*TB 1-1520-238-30-20

DEPARTMENT OF THE ARMY TECHNICAL BULLETIN

IGB DIFFUSER REPAIR PROCEDURES FOR ALL AH-64 SERIES AIRCRAFT

10 SEPTEMBER 2004

Figure 1. Trim of Diffuser, View Looking Forward

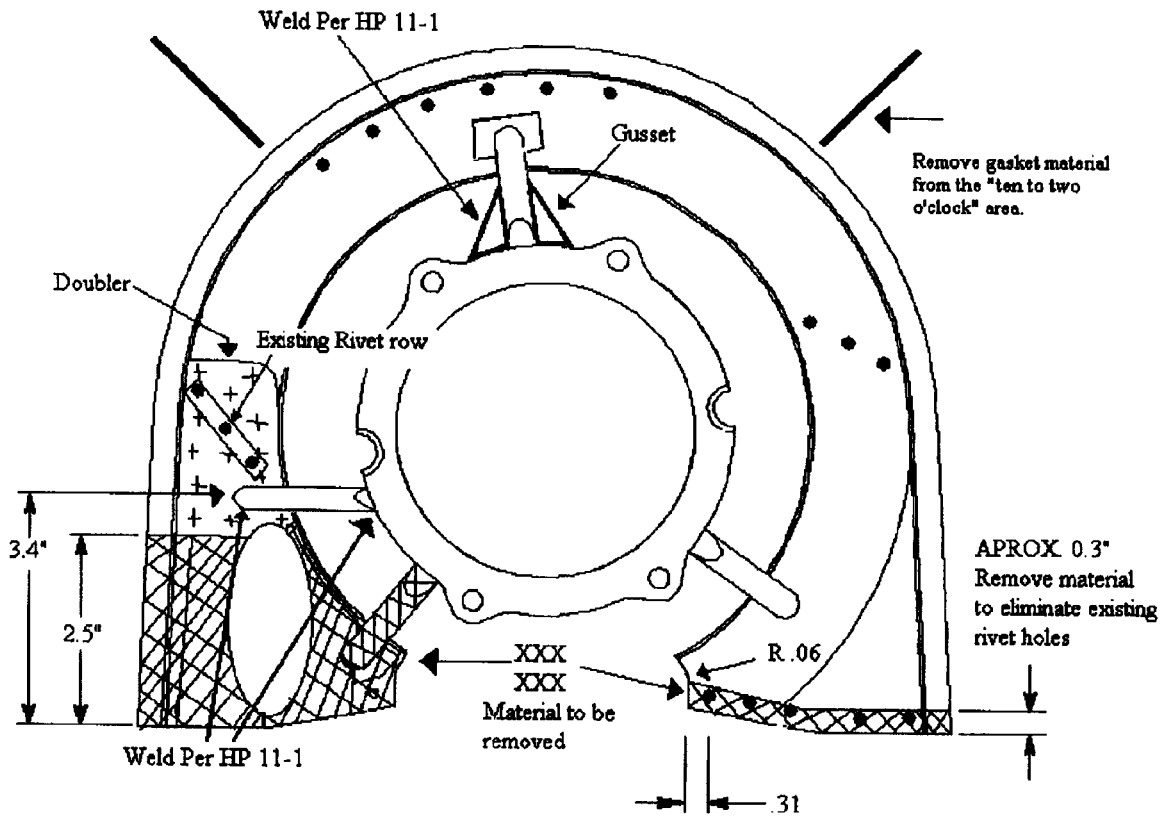
13.5. Inspect depth of damage to skin. See Figure 1 for possible chafe areas. If damage is greater than 10% (.006 inch) of fuselage skin thickness, contact AMCOM Engineering or Boeing Engineering. If damage is less than 10% (.006 inch) of skin thickness, blend to assure smooth transitions without deepening damaged area.

- 14.1. Fabricate Doubler per Figure 3. Break corners. Install per Figure 1.
- 14.2. Fabricate Leg per Figure 4. NDI after fabrication TM 1-1500-335-23. Install per Figure 1. (Weld per step 14.7.).

- 14.14. Reinstall right bottom plate (P/N 7-311332020-5). Use existing holes in bracket to locate rivets per Figure 2.
- 14.15. Remove gasket material from the "Ten to Two o'clock" area per Figures 1 and 2.

- 17.10. Position gussets IAW Figures 1 and 5.
- 17.11. Weld gussets per above procedure.
- 17.12. Inspect repaired area IAW reference TM 1-1500-335-23 Nondestructive Inspection Methods.

Figure 3. Doubler Layout

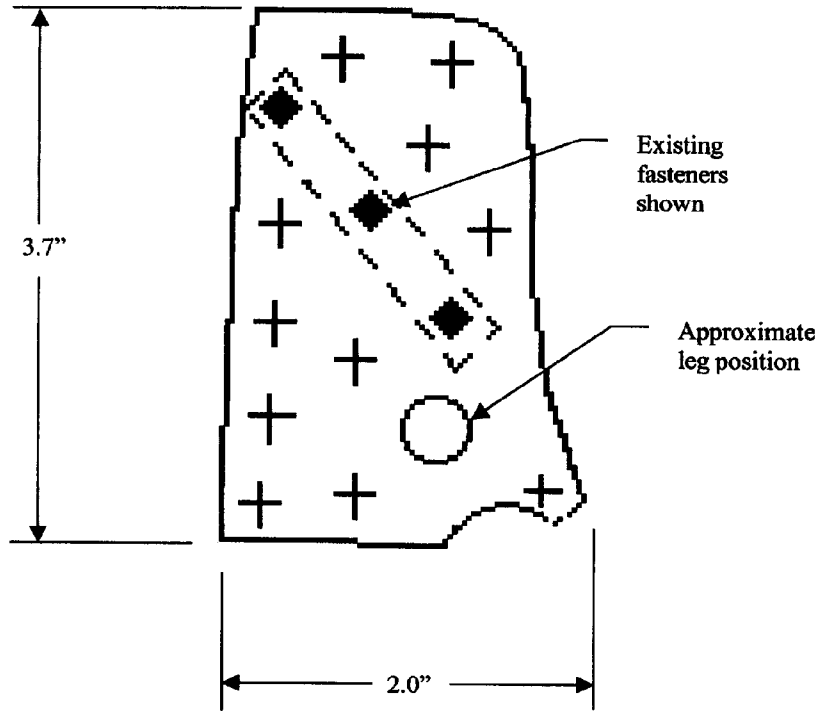
- 14.11. Drill out existing rivets and remove right hand bottom plate (P/N 7-311332020-5).
- 14.12. Layout and trim pattern per Figure 3.
- 14.13. Trim diffuser, and break sharp edges.

Fabricate doubler from .080 - .090 thick
6061T4 or T651 AL ALY sheet

Shape doubler as required to match contour of diffuser.
Round all corners of doubler.
Dimensions given are of the approximate size.
Fastener pattern approximately as shown.

Figure 4. Fabricate Leg

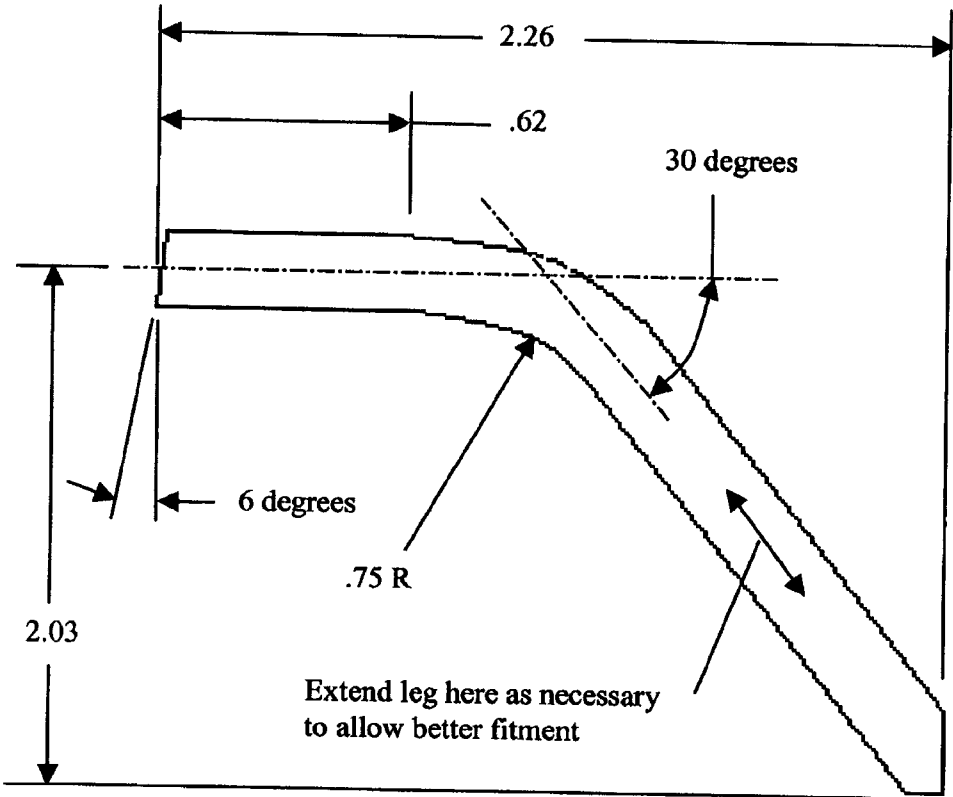
Fabricate new leg from .43 - .50 diameter 6061T4 or T6 AL ALY rod
Adjust angle of bend or extend leg as shown to allow better fitment upon assembly

Figure 5. Gusset Location

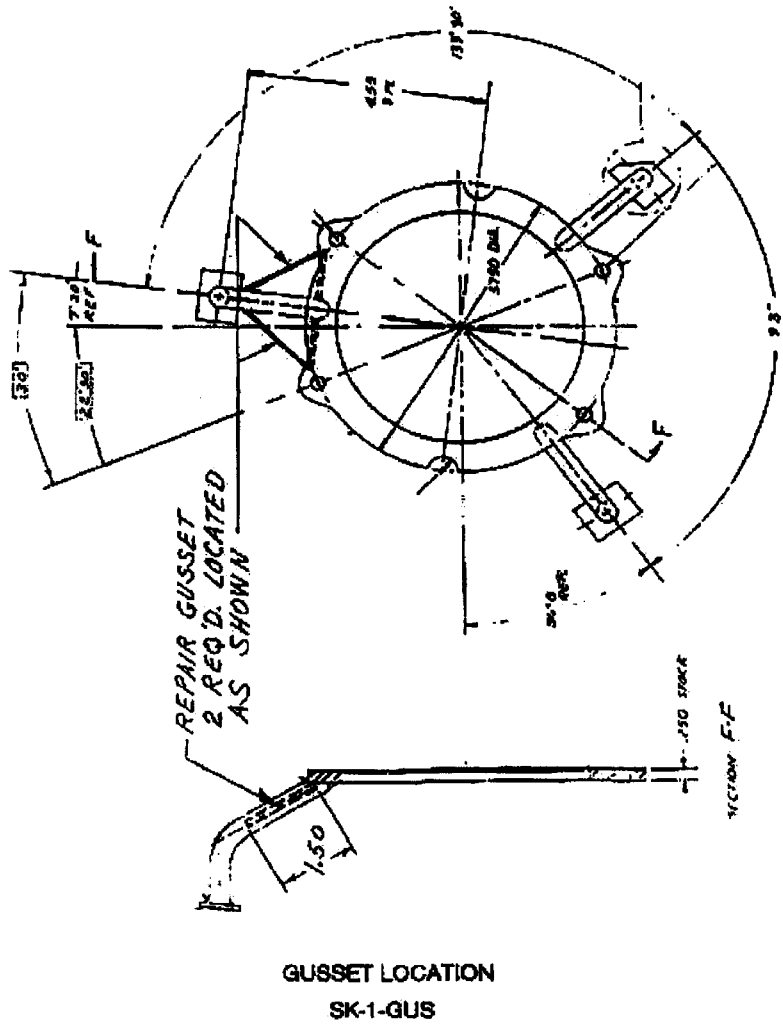
- 17.1. Remove paint from repair area, shown in Figure 5.
- 17.2. Remove rubber extrusion seal (bulb seal) HS4028-2724 from Diffuser, as required.
- 17.3. Remove Naugahyde seals, 7-311332020-37 & -39, as required.

- 17.4. Fabricate two gussets from 0.090 inch 6061-T6 aluminum, 1.0 X 1.5 inch, triangular shape IAW Figure 5, trim to fit.
- 17.5. Clean all surfaces to be welded with alcohol soaked, lint free cloth.

Figure 6. Modification of IGB Fairing

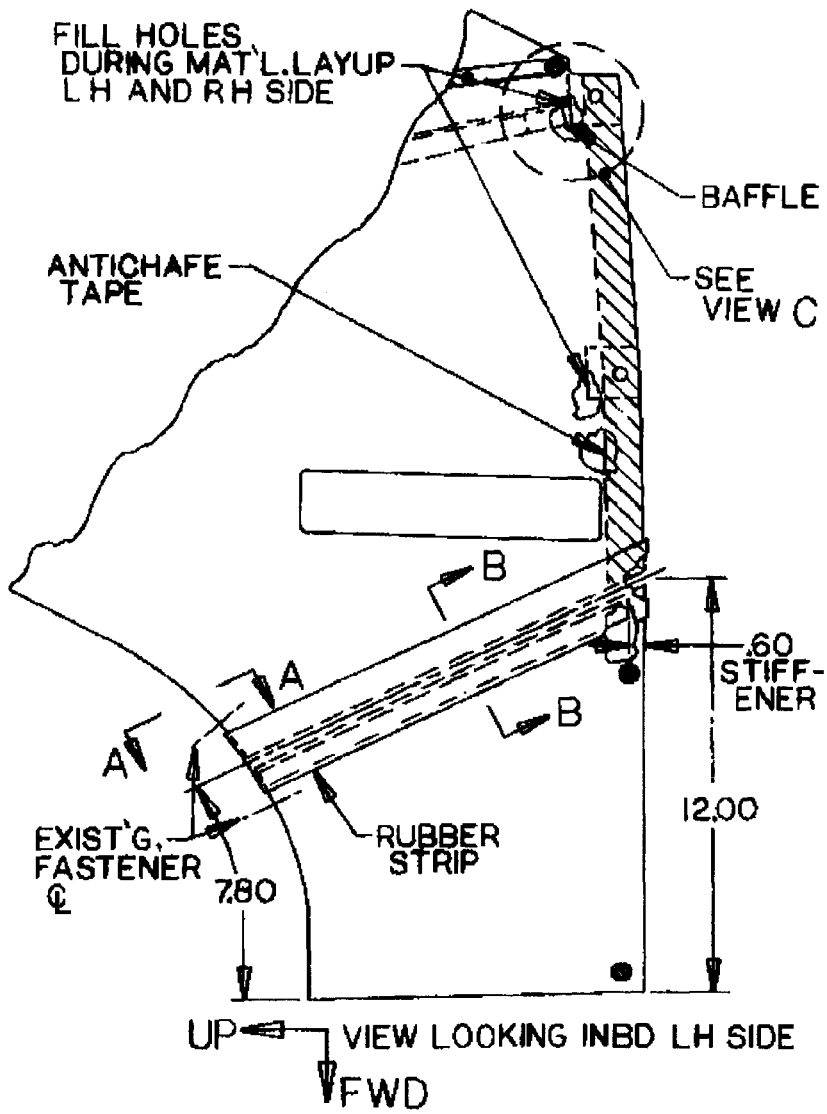
- 16.1. Remove the IGB Fairings 7-311122620-47 and -48 per applicable maintenance manual: see reference item 18.1, 18.2 or 18.3.
- 16.2. Mark trim-line of fairing per dimensions in Figure 6. Split the -47 and -48 fairings using Die Grinder with a cutting wheel. Allow a .20 gap when re-aligned.

- 16.3. Trim internal baffle of -47 fairing as shown in Figure 8.
- 16.4. Remove grommets, studs, washers, and ejector springs in areas indicated for holes to be filled (4 places) per Figure 6.

- 16.5. Fill holes with EA9313 per Figure 6.
- 16.6. Lay up a 1.6" X 1.6" sheet of Kevlar cloth using same EA9313.
- 16.7. Position stiffeners, P/N 7-311122620-7 and -9, per dimensions in Figures 6 and 7. Bond using EA9309.3NA.

- 16.12. Apply a fillet of AMS-S-8802 CLB-2, sealant to the forward and aft edges of the rubber strips.
- 16.13. Apply Anti-Chafe tape per Figure 6 to both fairing halves.

Figure 7. Modification of IGB Fairing

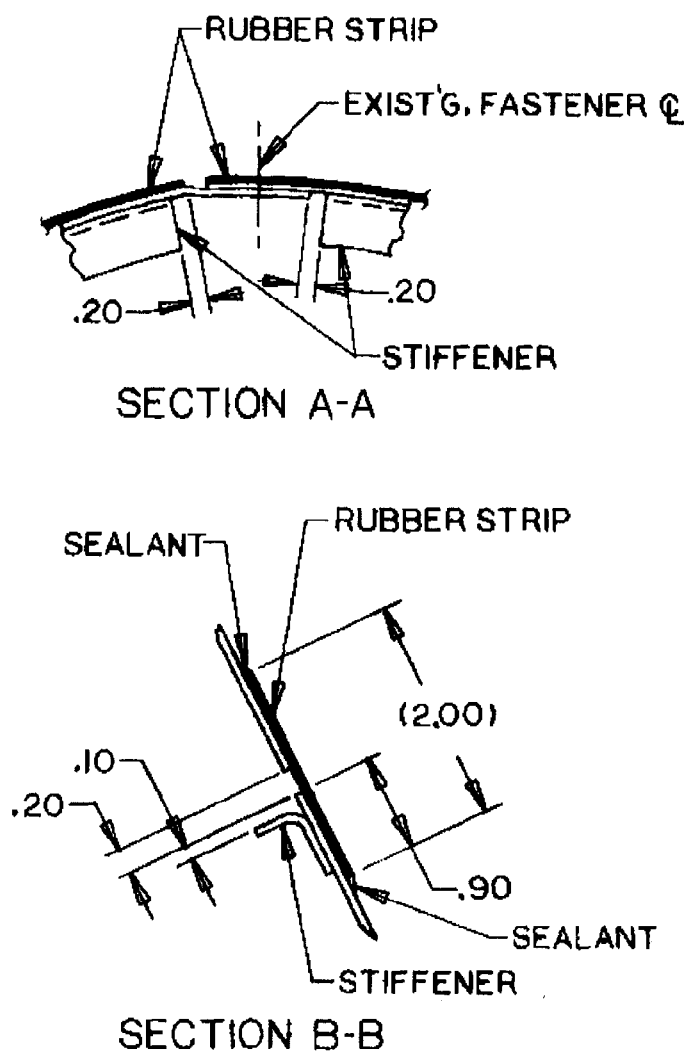
- 16.8. Reinstall -47 and -48 fairing onto aircraft.
- 16.9. Install 3M 8641 Tape to the outsides of the -47 and -48 fairings maintaining a 0.20 inch gap as shown in Figure 7. Prime fairing surface before installation using 3M #86 primer per manufacturer's instructions.

Figure 9. Radius Requirement

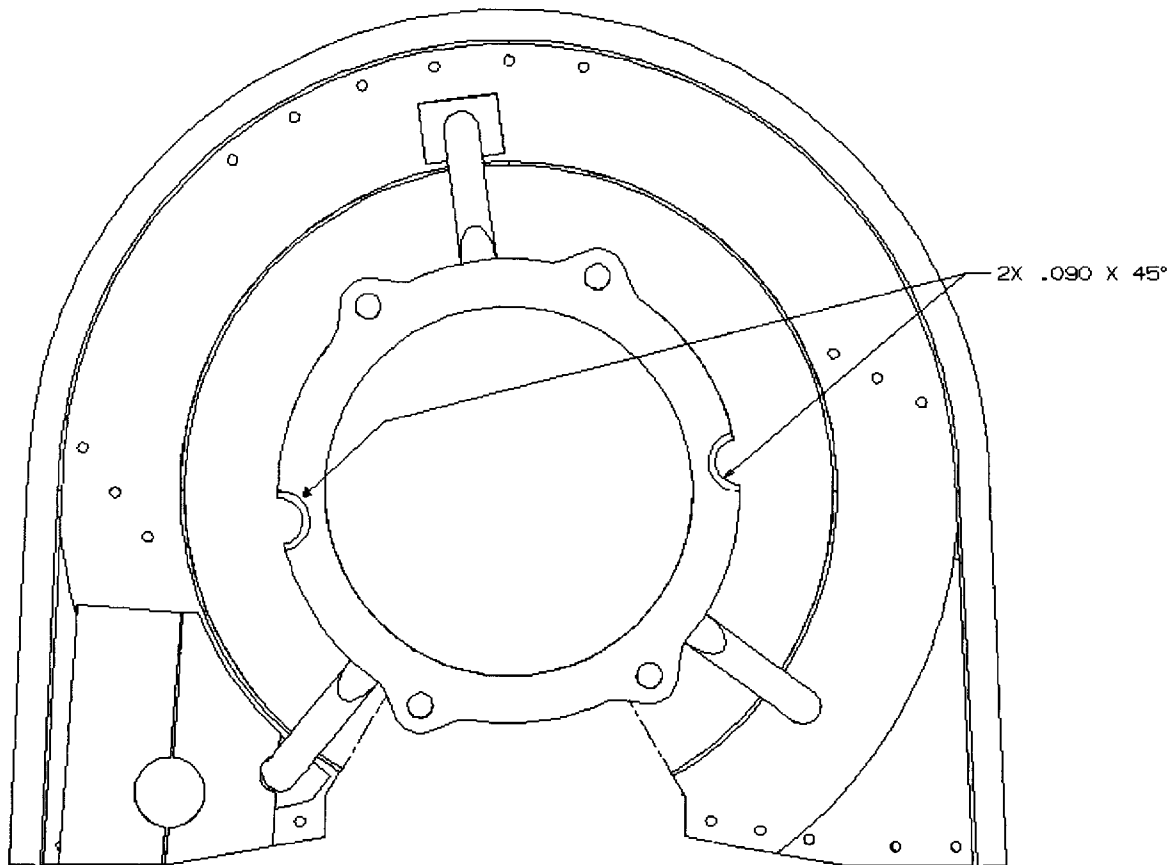
13.4. Radius two (2) areas as indicated on figure 9 if required. Touch-up all reworked areas using MIL-C-5541, Class 1A (corrosion resistant coating) and MIL-PRF-85582, Type 1, Class 2 (paint primer).
